Service Bulletin

BULLETIN # 271

WELDARC 145i

WELDARC 145I (MC106) FAN CABLE EXTENSION

Figure 1 - Fan in its original orientation

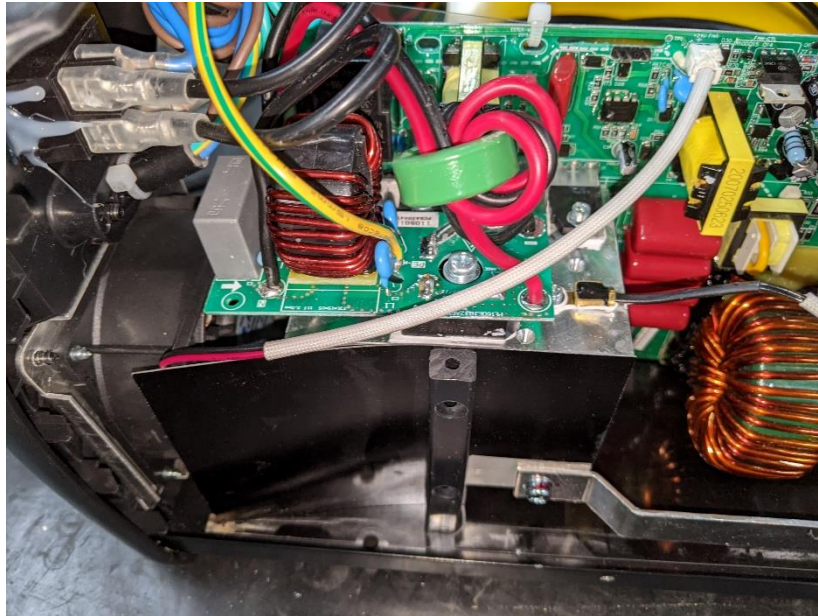
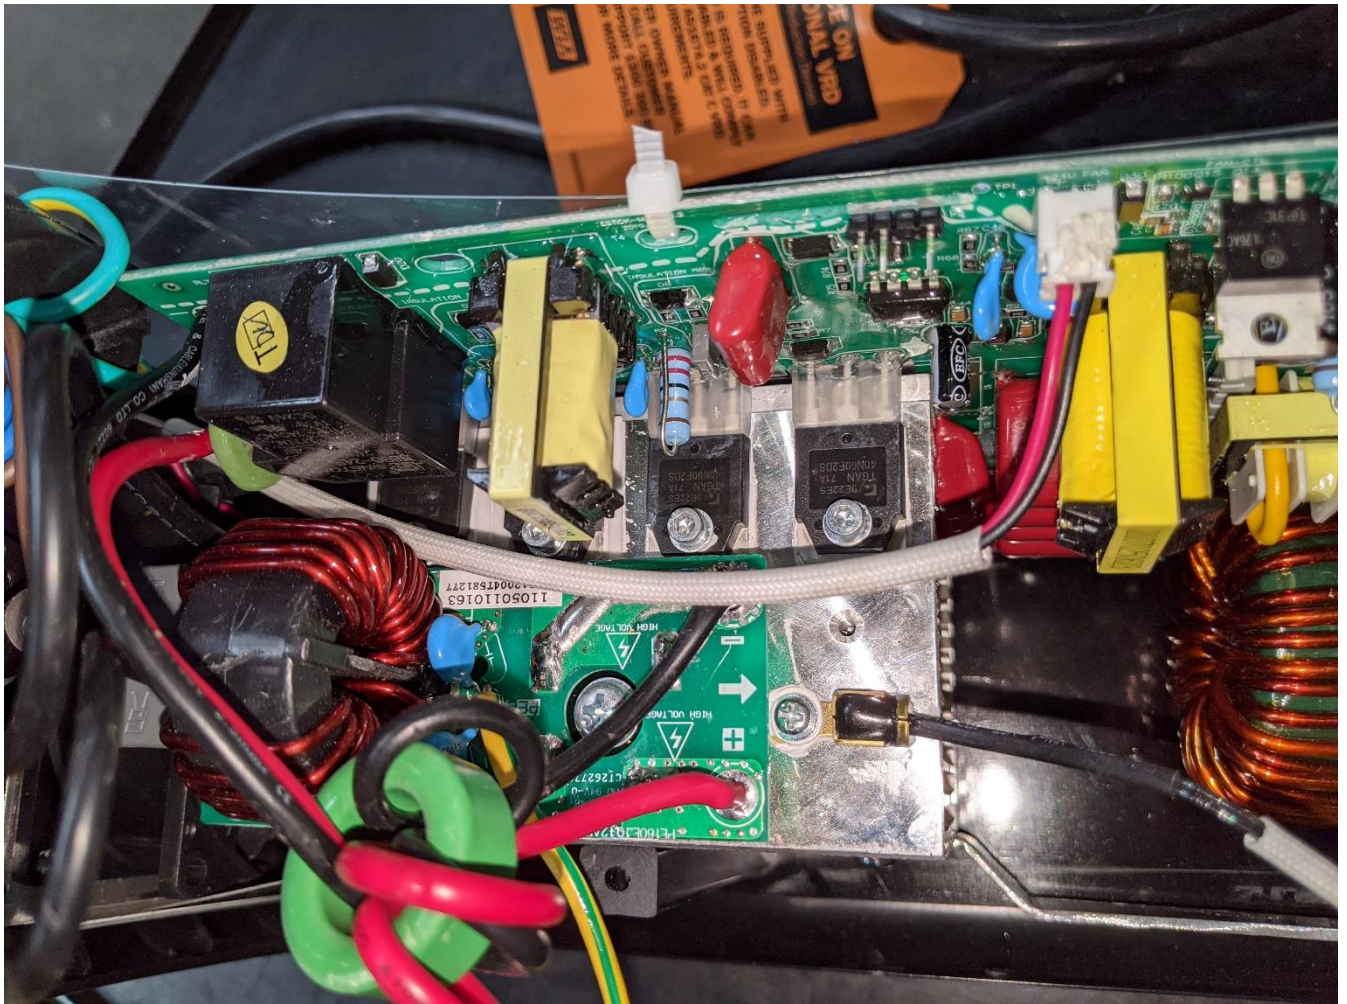
The Weldarc 145i has had service agents experiencing difficulty with the removal of covers and the attachment of the fan cable to the main control PCB.

The difficulty has been experienced as the fan has been fitted as per the orientation in Figure 1. By rotating the fan 90° and looming the cable through the power cables to the connection, an additional 30mm is gained (see Figure 3). This additional length allows the removal and fitting of covers without the additional risk of disconnecting the fan cable.

Figure 2 - Rear panel detached for access

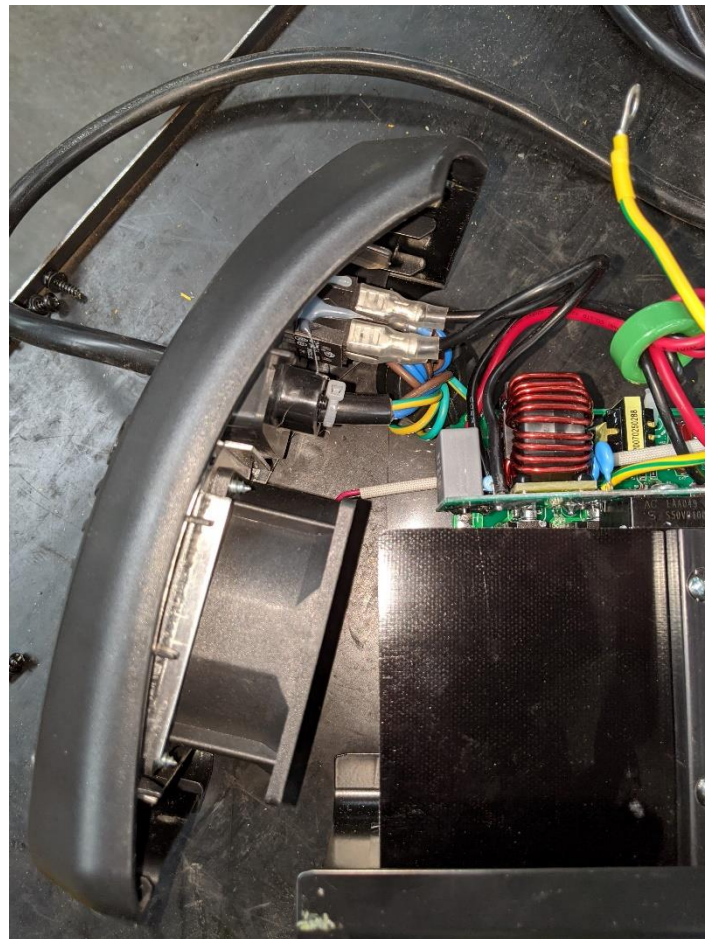
The rear panel can be removed enough to reposition the fan without the need for disconnection of other components (see Figure 2).
